## Supplemental Information for 021-511 or 120694 Angle Drive (Speedometer Cable to Gearbox) Austin Healey BN4-BJ8, MGB 63 on, TR'S 63 on

# TECHNICAL SERVICE BULLETIN

Re: Right Angled Speedometer Adaptor Failures

WASHER 3H 550

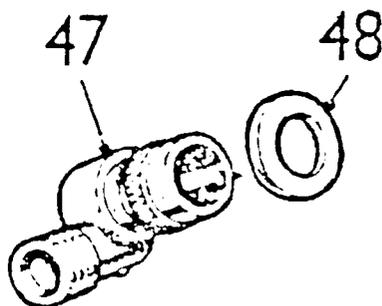
Repeated failures of the above have, in many instances, been caused by Washer-Adaptor to gearbox Part Number 3H 550 not being fitted when a new right angled drive adaptor is installed.

This causes an excessive end load and premature failure of the right angled drive pinion.

***IMPORTANT! When fitting the angle drive, fit a 324-720 or 3H550 washer as shown on the next page.***
